TRANS/WP.29/GRSG/57
28 July 2000

Working Party on General Safety Provisions (GRSG)

REPORT OF THE WORKING PARTY ON GENERAL SAFETY PROVISIONS (GRSG)
ON ITS SEVENTY-EIGHTH SESSION

Annex 2

Figure 3: determination of the datum points
 (example of a left-hand vehicle)"

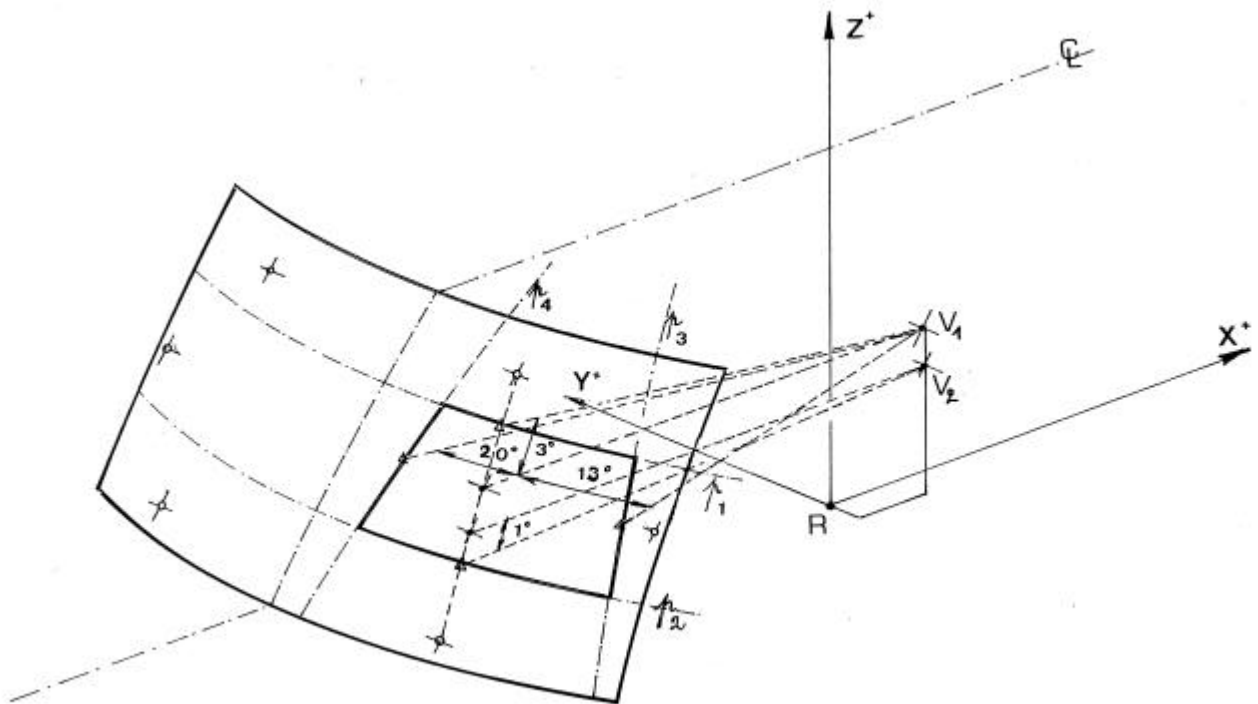
2.5. Definition of the datum points (see figure 3)

2.5.1. upper vertical datum point forward of V1 and 7° above the horizontal (Pr1);

2.5.2. lower vertical datum point forward of V2 and 5° below the horizontal (Pr2);

2.5.3. horizontal datum point forward of V1 and 17° to the left (Pr3);

2.5.4. three additional datum points symmetrical to the points defined under paragraphs 2.5.1. to 2.5.3. in relation to the longitudinal median plane of the vehicle (respectively Pr'1, Pr'2, Pr'3)."

Figure 1: test area "A" (example of a left-hand vehicle)

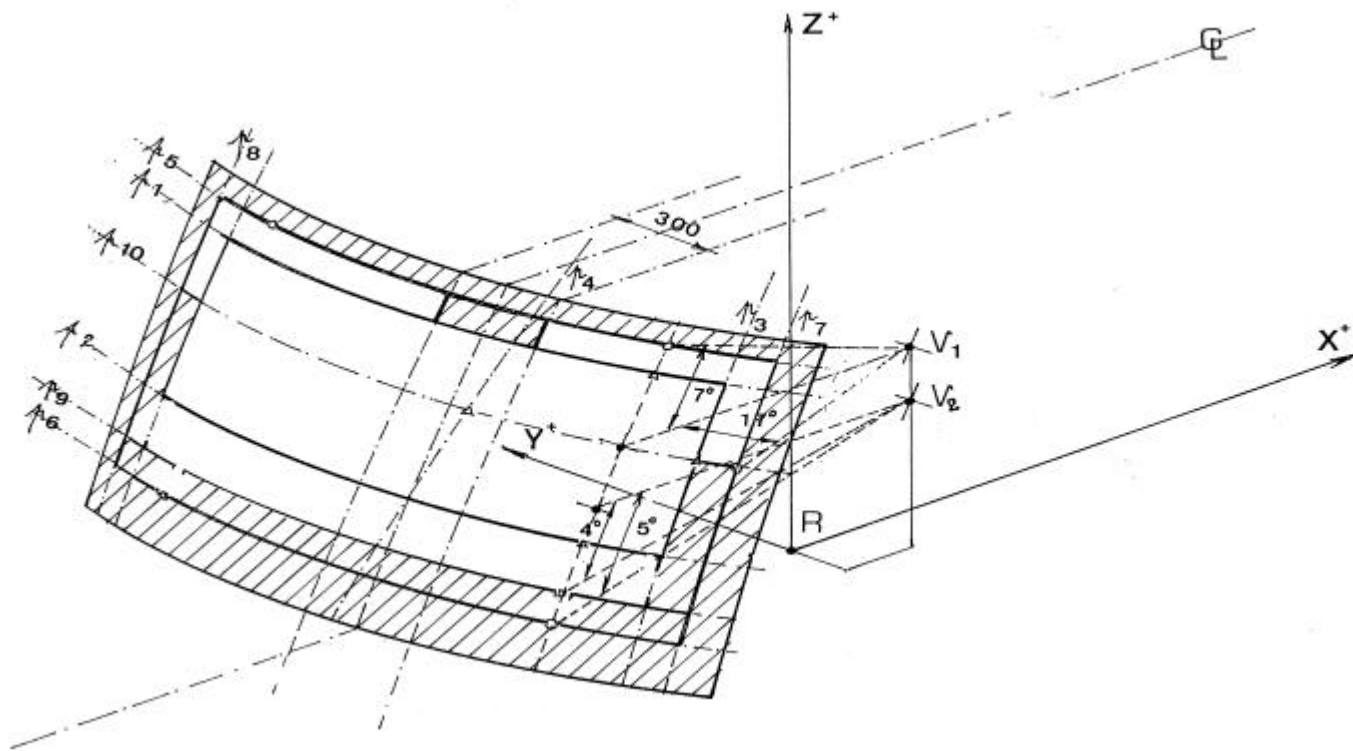
- "2.2. "Test area A" is the area of the outer surface of the windscreen bounded by the intersection of the following four planes (see figure 1):
- (a) a plane inclined upwards from the X axis at 3°, passing through V₁, and parallel to the Y axis (plane 1);
 - (b) a plane inclined downwards from the X axis at 1°, passing through V₂, and parallel to the Y axis (plane 2);
 - (c) a vertical plane passing through V₁ and V₂ and inclined at 13° to the left of the X axis in the case of left-hand drive vehicles and to the right of the X axis in the case of right-hand drive vehicles (plane 3);
 - (d) a vertical plane passing through V₁ and V₂ and inclined at 20° to the right of the X axis in the case of left-hand drive vehicles and to the left of the X axis in the case of right-hand drive vehicles (plane 4)."

Figure 2a: reduced test area "B" (example of a left-hand vehicle) - upper obscuration area as defined in paragraph 2.4.2.2.

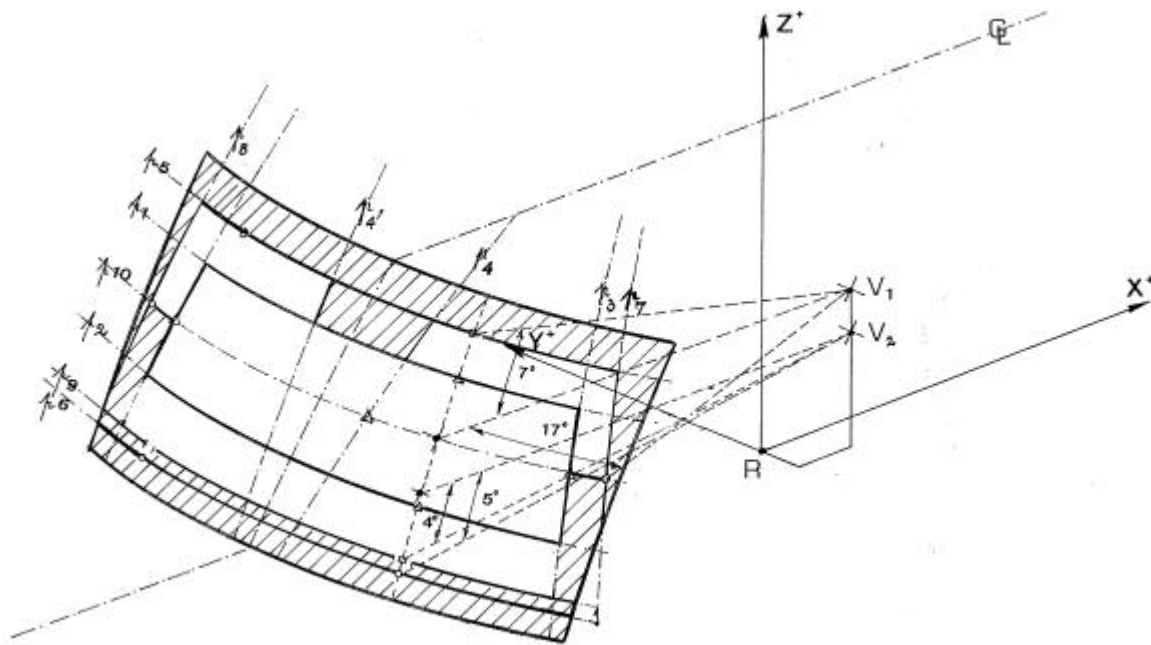
- 2.4.2.2. any opaque obscuration bounded downwards by plane 1, of maximum width 150 mm 2/, provided it is inscribed in an area of width 300 mm centred on the longitudinal median plane of the vehicle;

Figure 2b: reduced test area "B" (example of a left-hand vehicle)
- upper obscuration area as defined in paragraph 2.4.2.1.

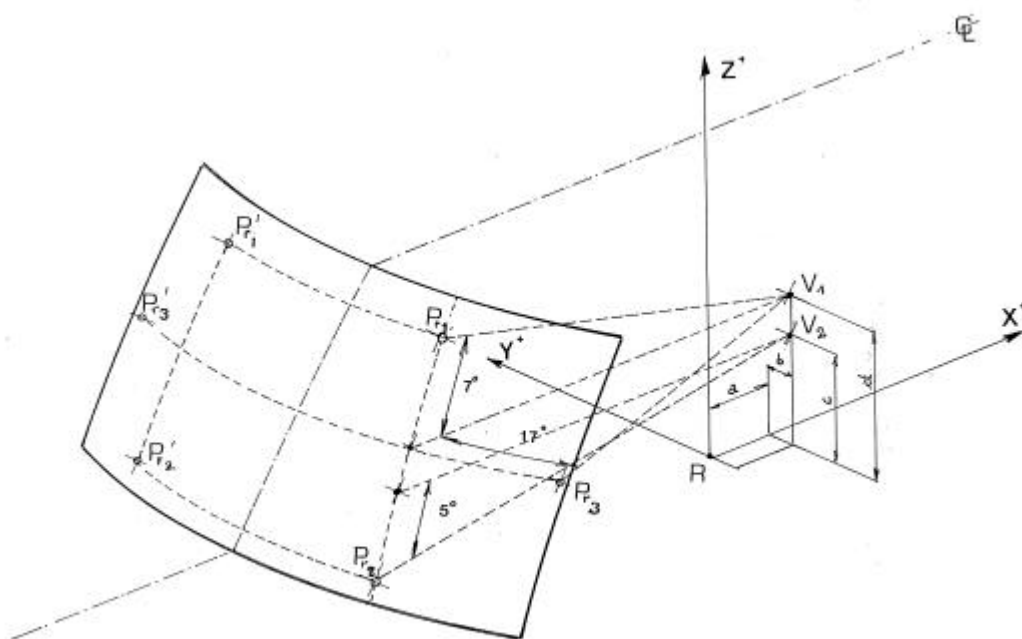
- 2.4.2. at the discretion of the vehicle manufacturer, one of the two following paragraphs may apply:
- 2.4.2.1. any opaque obscuration bounded downwards by plane 1 and laterally by plane 4 and its symmetrical in relation to the longitudinal median plane of the vehicle (plane 4');;
